Planning and Zoning Board Agenda July 10, 2018

- A. Approval of the Minutes of the June 12, 2018 PZB Meeting
- B. Site Plan - San Felasco Tech City: A request by Clay Sweger, AICP, LEED AP, of EDA

Engineers - Surveyors - Planners, Inc., applicant and agent for Tom R. & Associates, LLC, property owner, for consideration of a Site Plan to construct two (2) ±30,100 square foot buildings, with associated paving, grading, drainage, and infrastructure improvements, on a ±55.36 acre subject property, consisting of a ±13.23 acre project area, located in the 12000 block of NW US Highway 441; Tax Parcel Number 05962-002-000 (Quasi-Judicial Hearing).

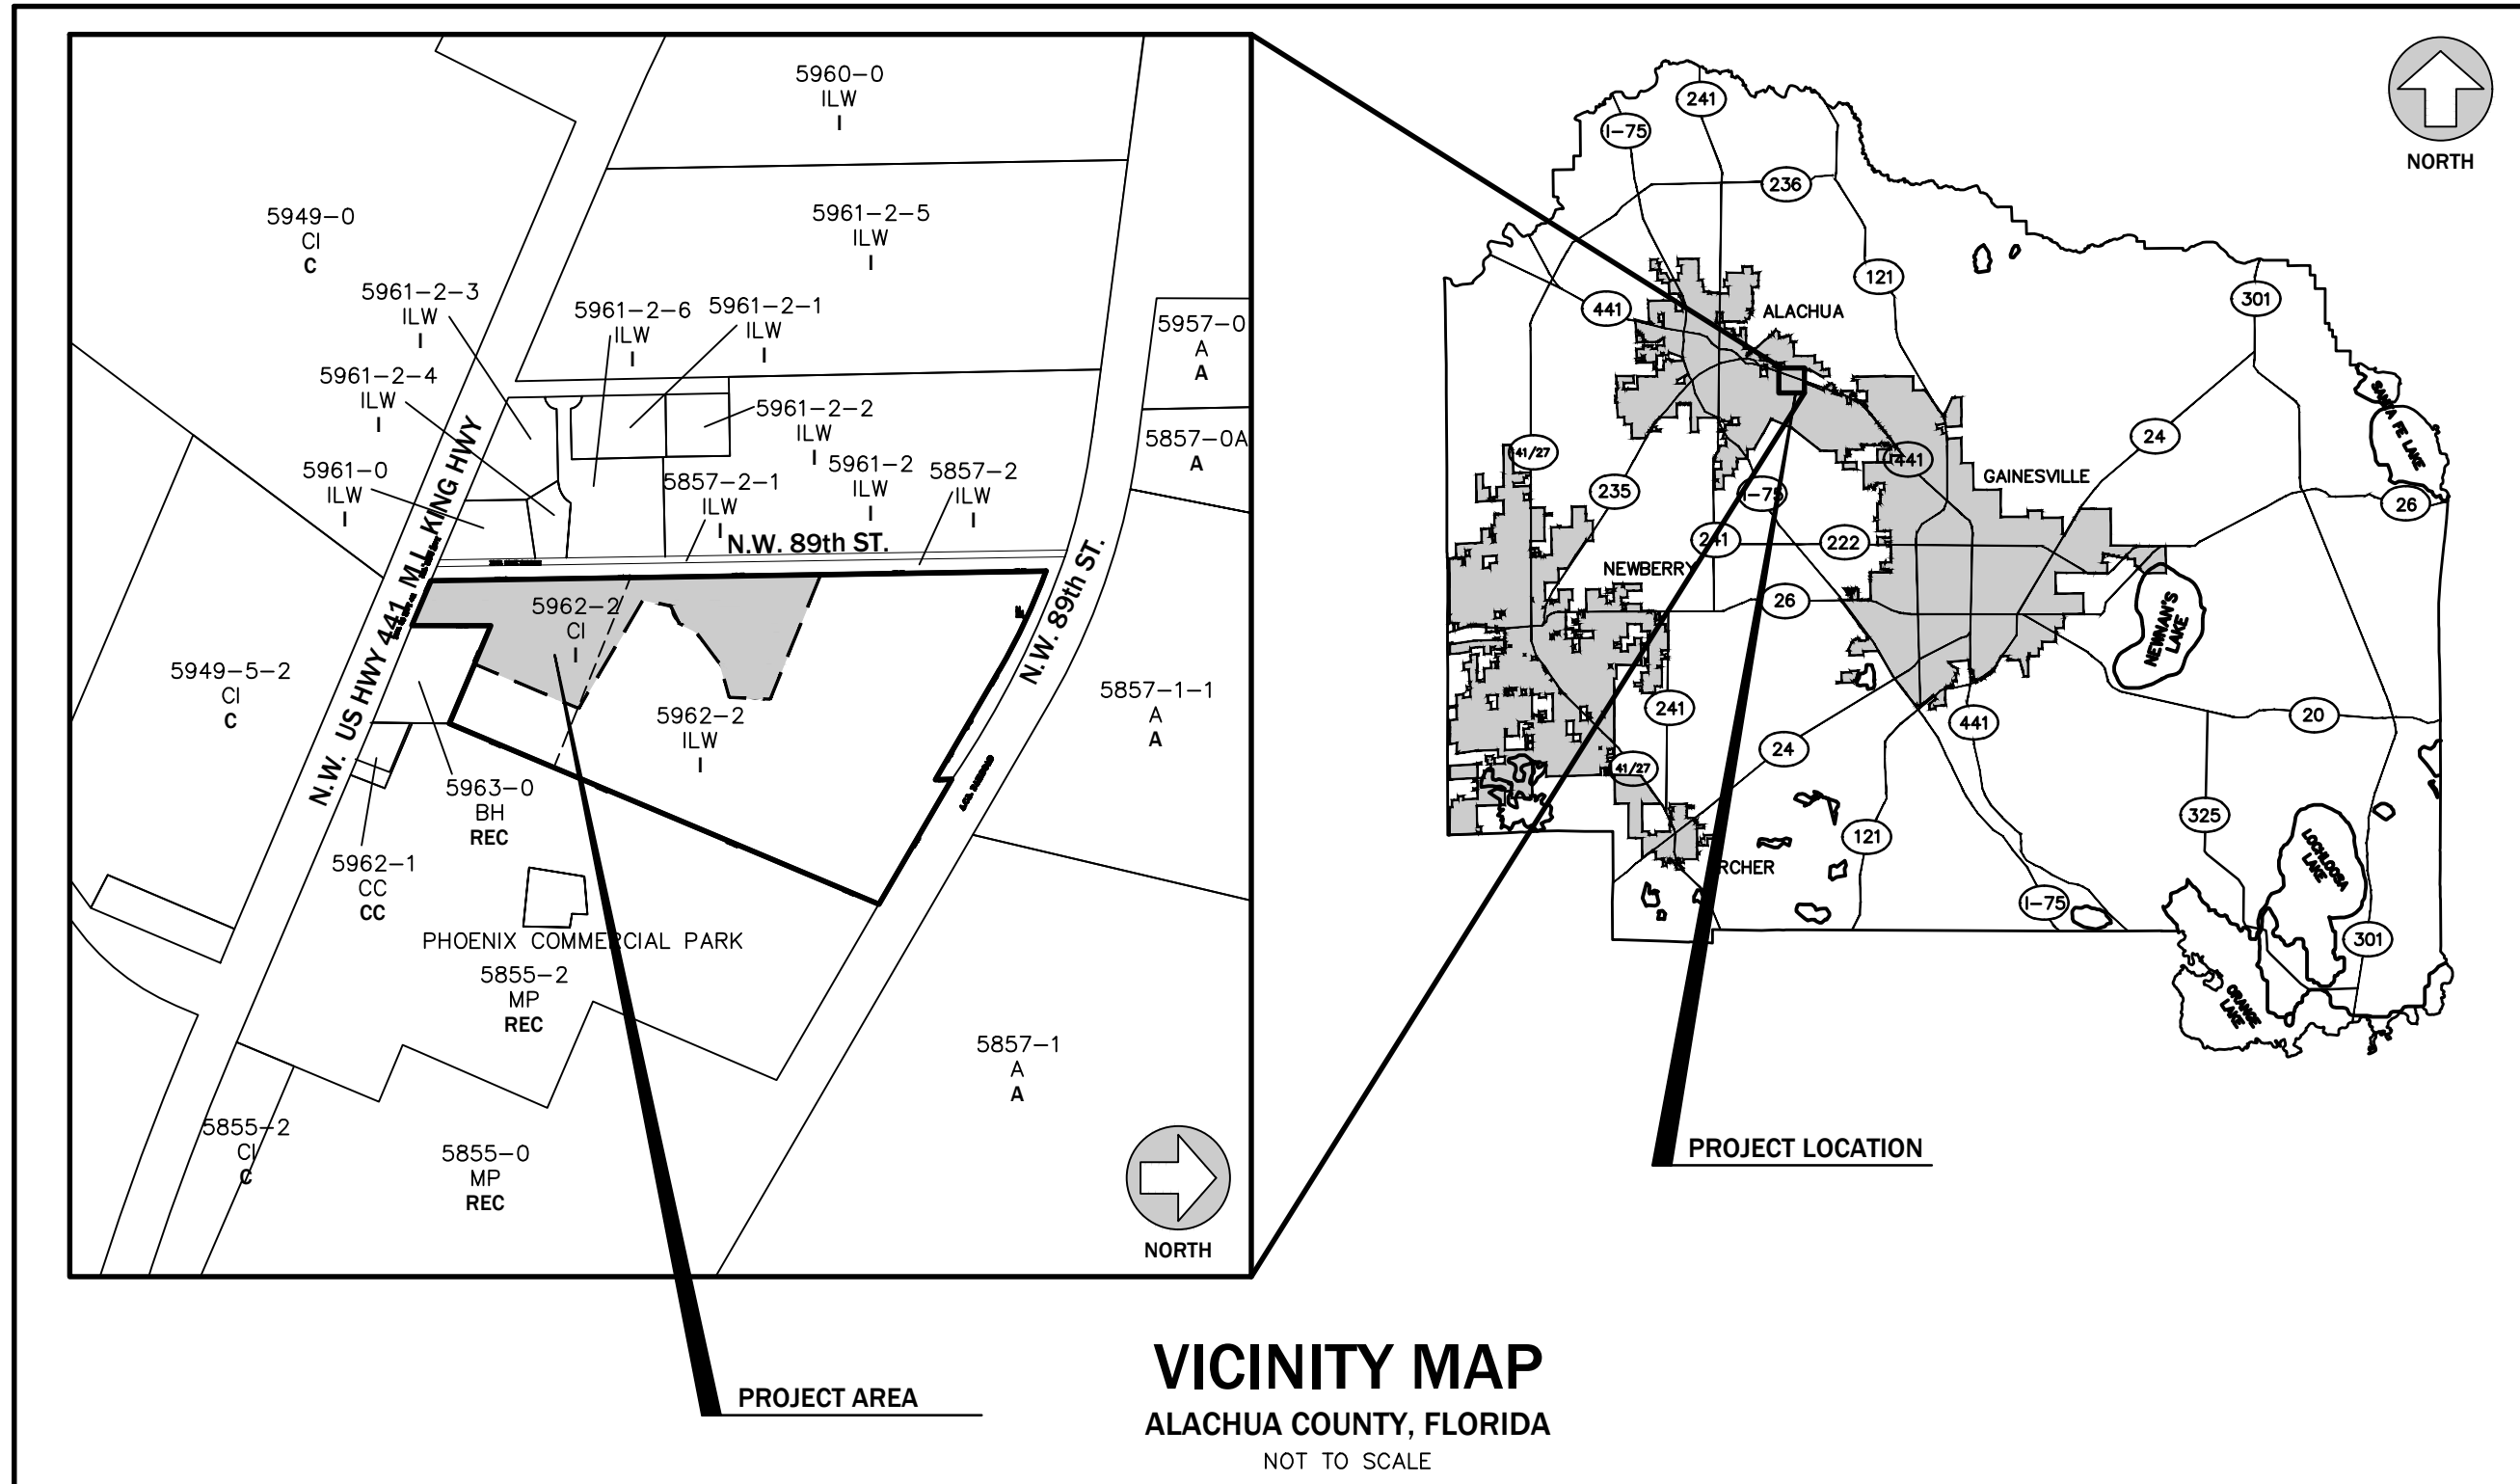
5. Sheet C0.00: Trip Generation:
 - a. Correct the "per 1000 SF" figures for each ITE Code to reflect the square footage shown in the first column.
 - b. Revise parking calculations for each ITE Code (total trips, project trips in and out, for AM, PM, and AADT trips) to reflect proposed square footage.
 - c. Revise Summary table to reflect the preceding corrections to calculations.

6. Sheet C0.00: Required parking for "retail" is 52 spaces [$16,000 / 305 = 52.45$, rounding to nearest whole number per Section 6.1.6(A)].

7. Sheet C0.00: The square footage of the "building" (sic – should be plural or "building area") calculation under Project Area Impervious Area Calculations is inconsistent with proposed building coverage in same table and with project description under Development Information. Please clarify.

- b. Per Table 6.1-1, parking requirement for office use types is 1 space per 330 square feet of floor area. Criteria of parking calculation on Sheet C0.00 lists 1 space per 350 square feet.

RESPONSE: Trip Generation tables have been revised and updated. Please see Trip Generation Calculations on sheet C0.00.

RESPONSE: Parking calculations have been revised. Please see parking calculation tables on sheet C0.00.

RESPONSE: Parking calculations have been revised. Please see sheet C0.00.

BASIN 1 TYPICAL SECTION A-A

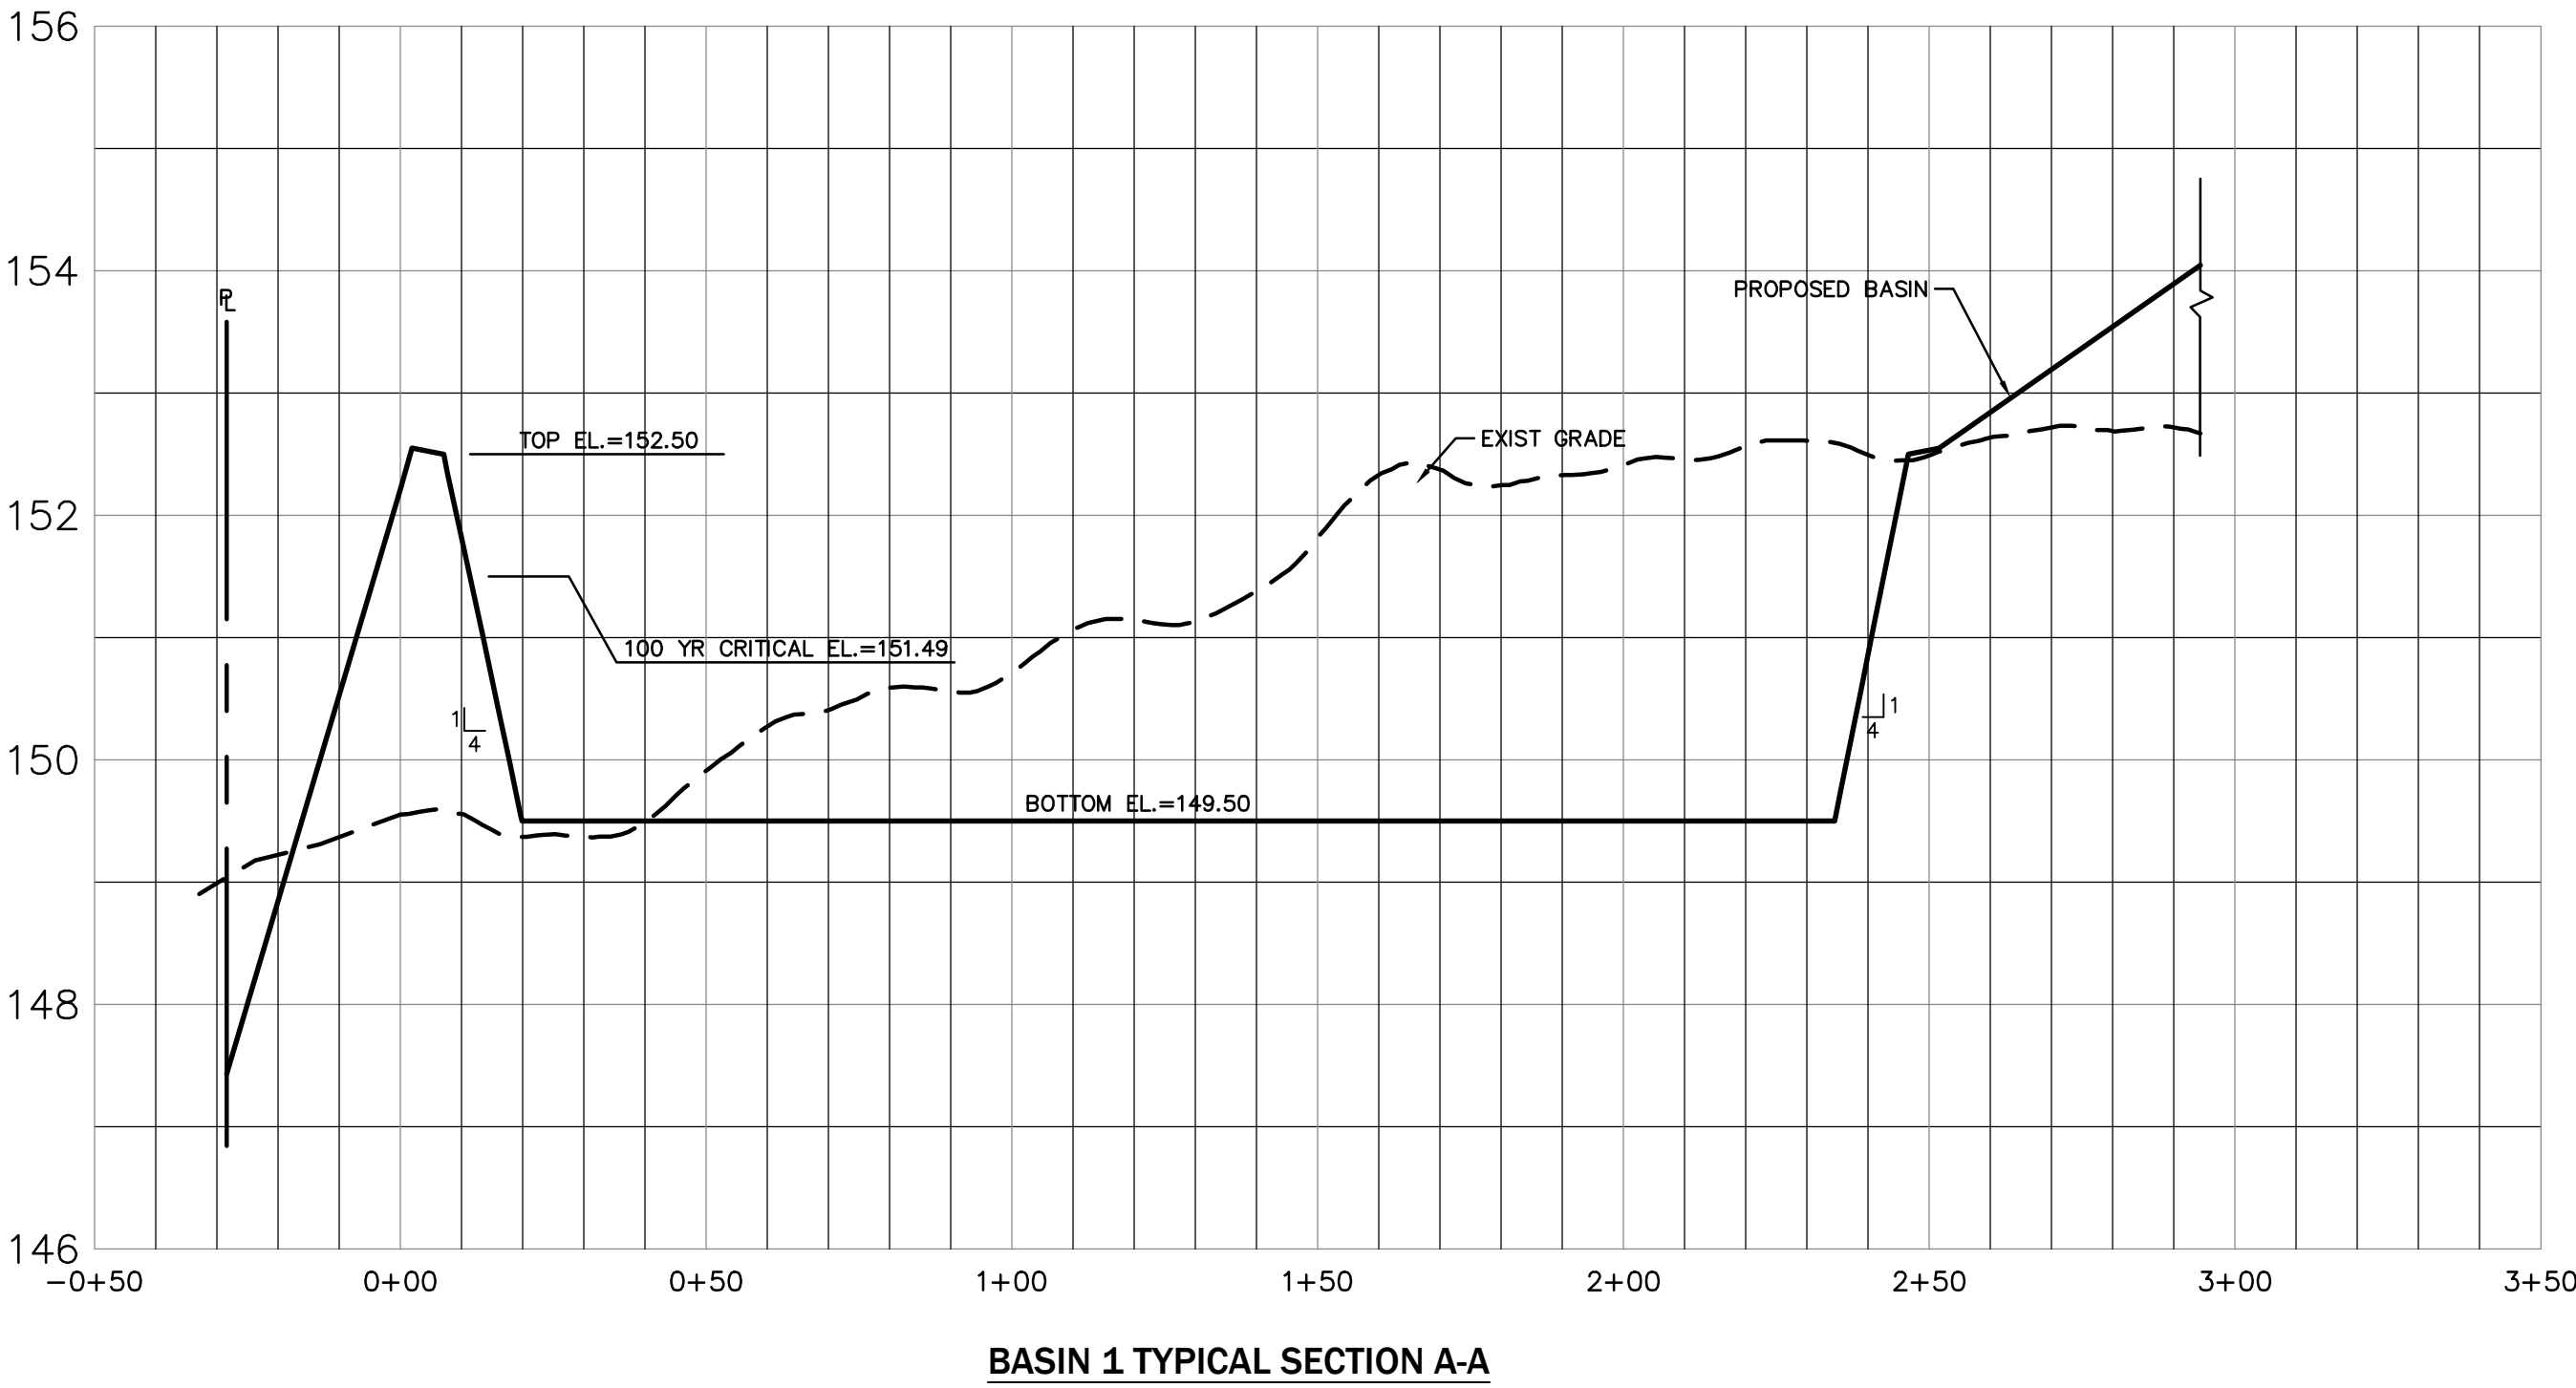
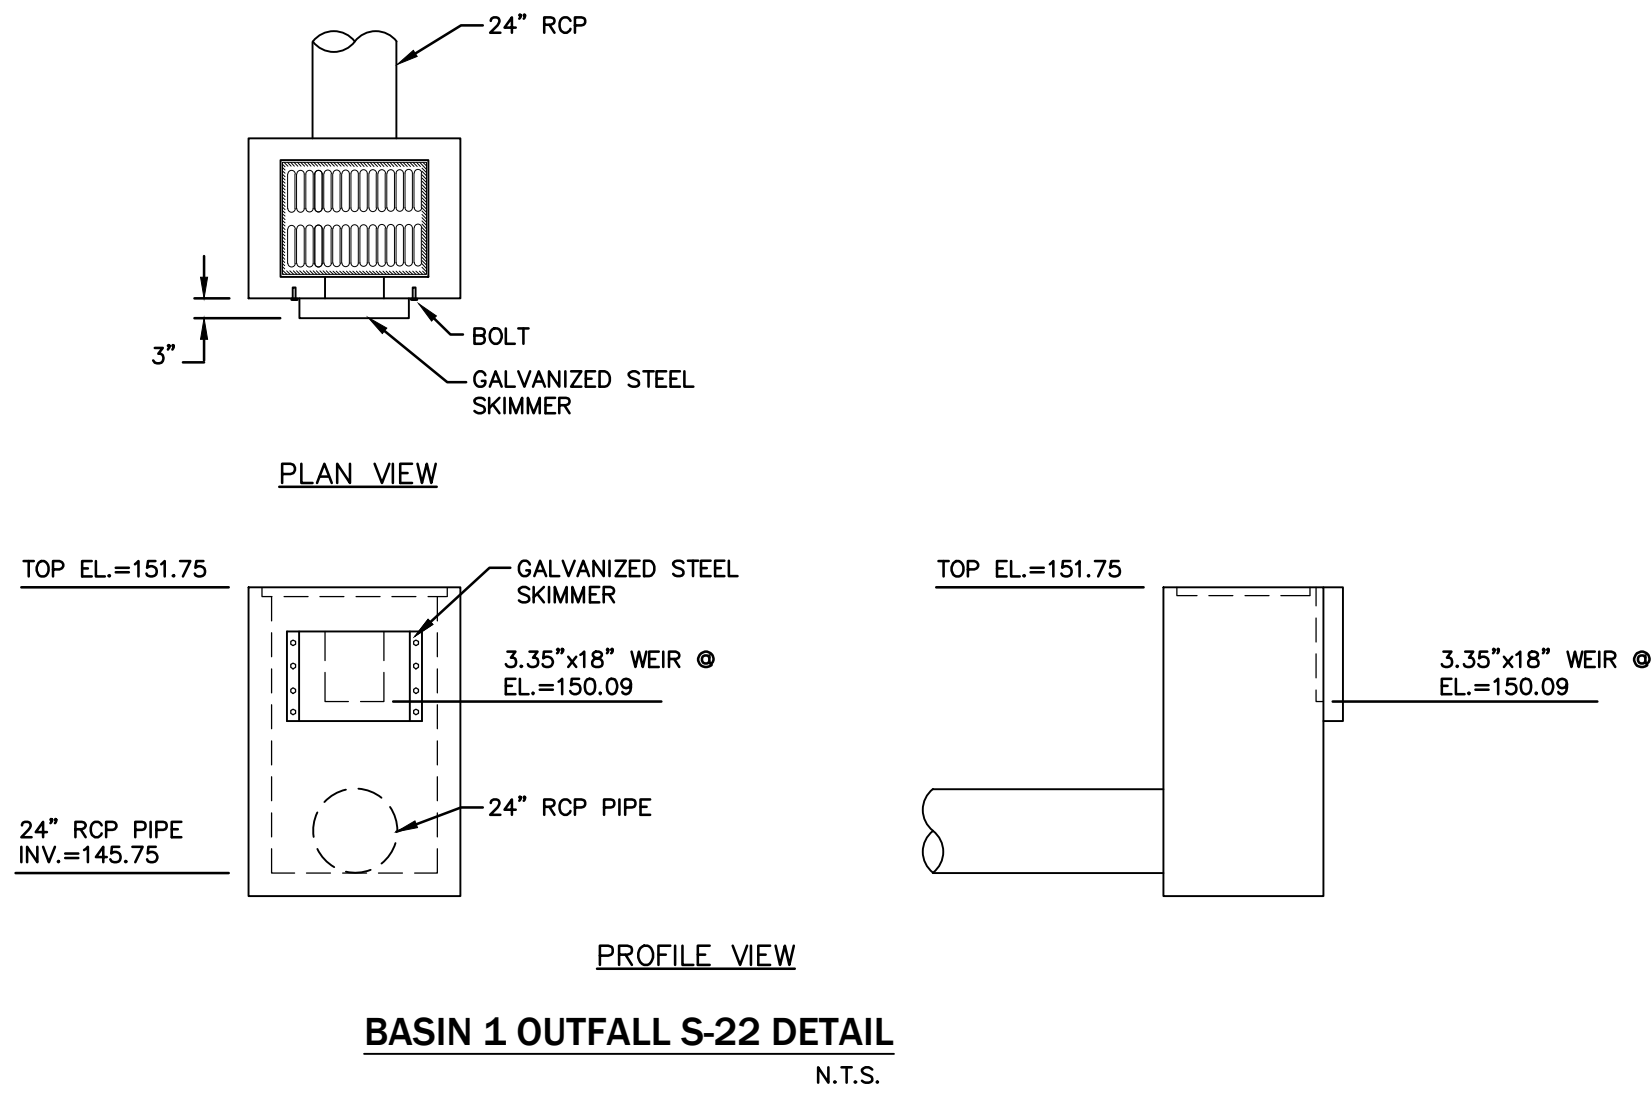
- i. C2.20, Maintenance Note 1: Please clarify the maintenance entity, as the site is presently undeveloped and there is not existing stormwater management system. Maintenance entity shall comply with Section 6.9.4(E)(2).

Remaining Issues: Plans (on Sheets C2.20 and C2.30) refer to the “~~existing~~ stormwater management system”.

RESPONSE: Plans have been corrected. See revised sheet C2.20 and C2.30.

RESPONSE: Maintenance entity is The Laser Investment Group, LLC. Please see revised sheet C2.20.
